A8 AcuSense NVR V4.51.200_211026

Release Notes

(2021-11-1)

1. Support access to HPC cloud platform

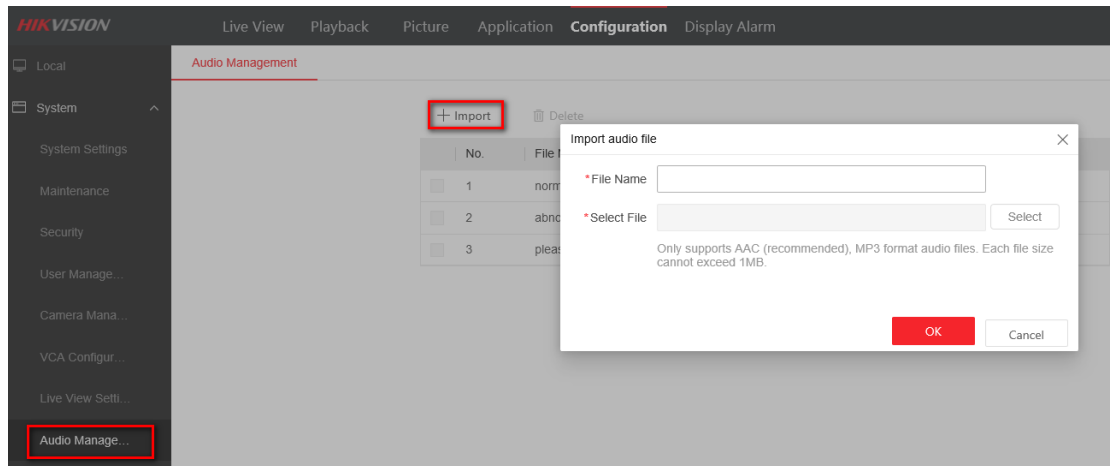
- a) Support upgrade devices by Hik-Pro-Connect client;
- b) Support download videos from Hik-Pro-Connect client;
- c) Support video playback on Hik-Pro-Connect client;
- d) Support upload alarm to HPC cloud platform.

3. Audible Warning (previous “Audible warning” change to “Buzzer”)

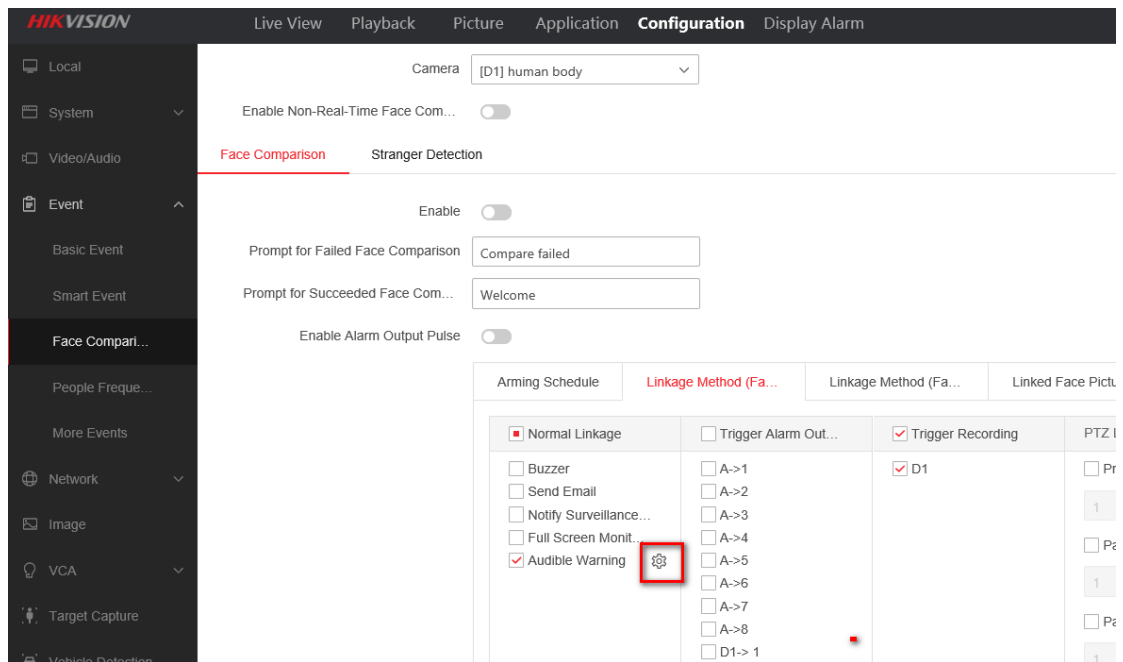
- a) Support users to import customized voice files via Web page or local GUI. The maximum capacity is 2MB, the size of a single audio file is 2K ~ 1MB, and the maximum support is 16 audio files.

- b) Default voice: Normal temperature, Abnormal temperature, Please wear a mask;
- c) Support AAC and MP3 format audio files (AAC is recommended);
- d) Support link customized audio files in alarm event, and can configure associated voice and arming schedule;

- e) Available functions: Face capture, Face comparison, Multi-Target-Type Detection, Perimeter.

6. Perimeter support shield region function

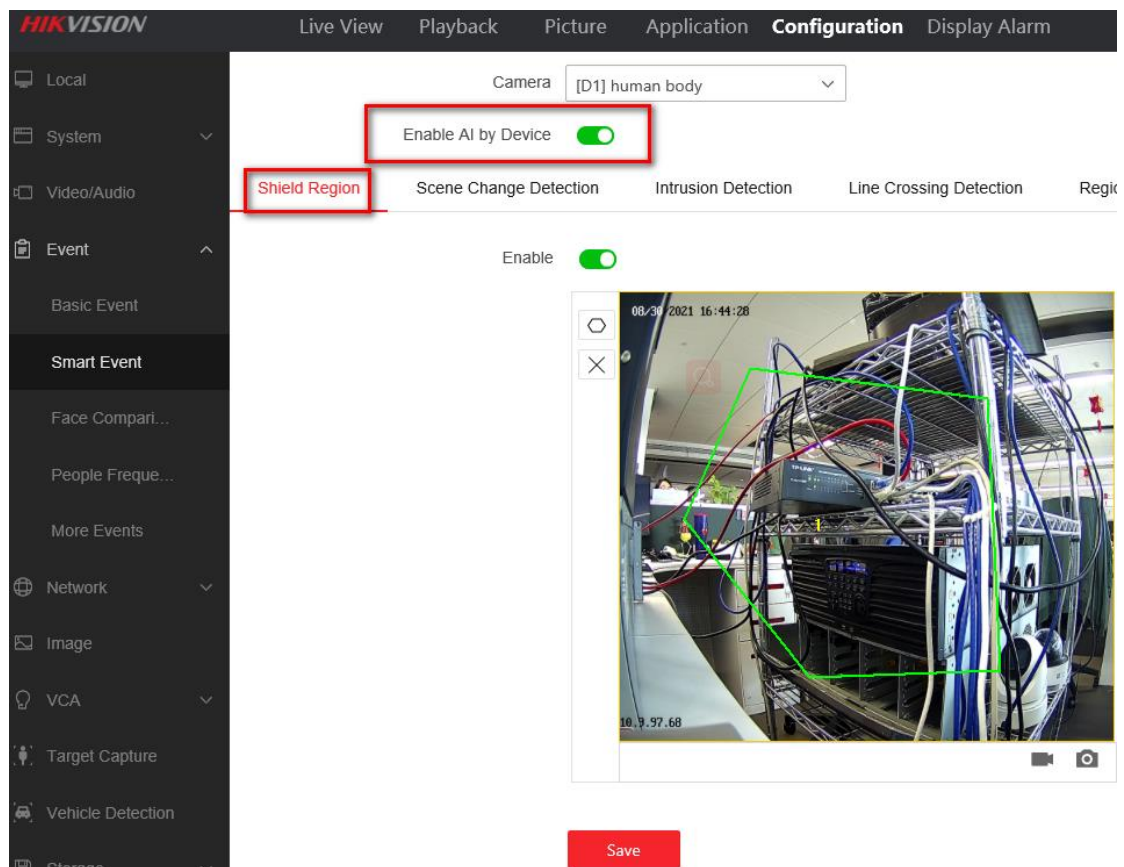
- a) After enable AI by device, there is Shield region configuration interface in every channel.
- b) Shield region is a channel level parameter (after the shielding region is configured, it will shield the corresponding areas of Line crossing, Intrusion, Region entrance and Region exiting at the same time).

7. Support alternate SMTP service configuration

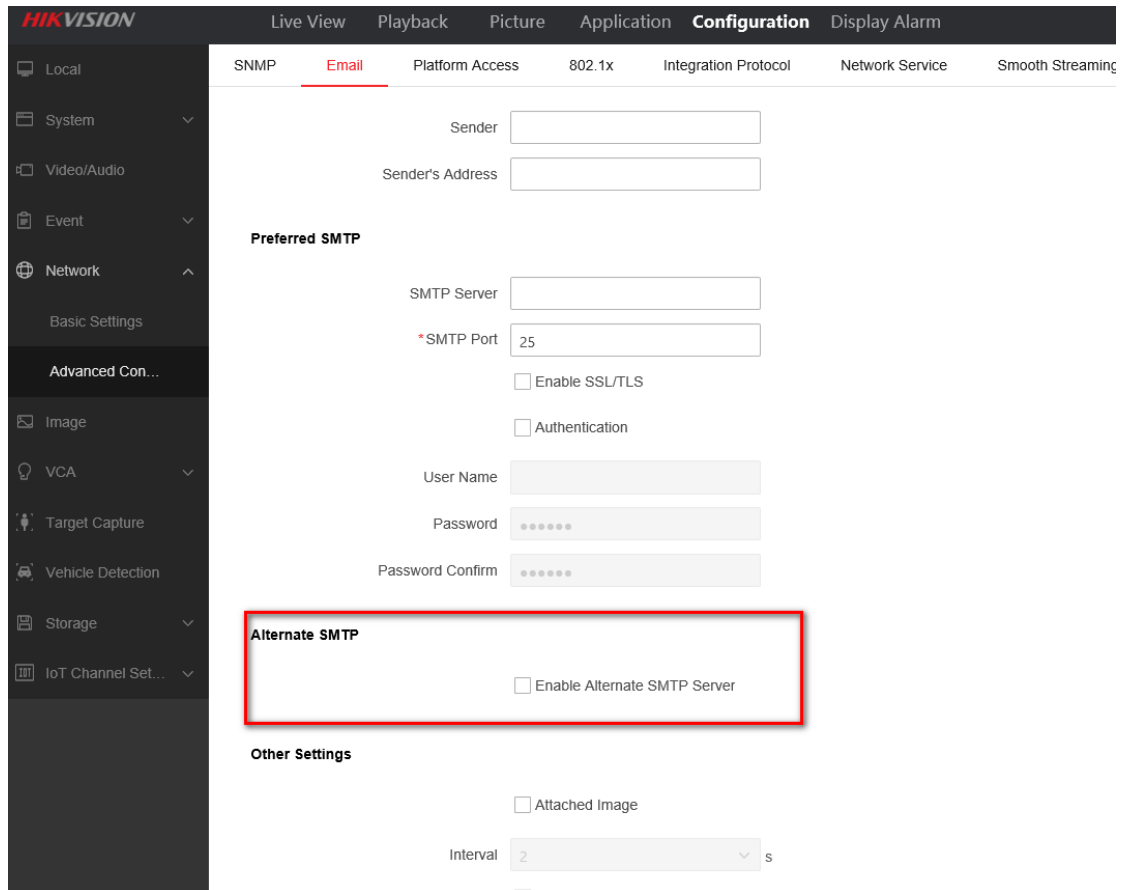
- a) Support configure alternate SMTP, if the email sent to preferred SMTP failed, it will send to the alternate SMTP.
- b) The email testing on Web page will only test preferred SMTP, the alternate SMTP won't be tested. The email testing on local GUI will test preferred SMTP firstly, then test alternate SMTP later.
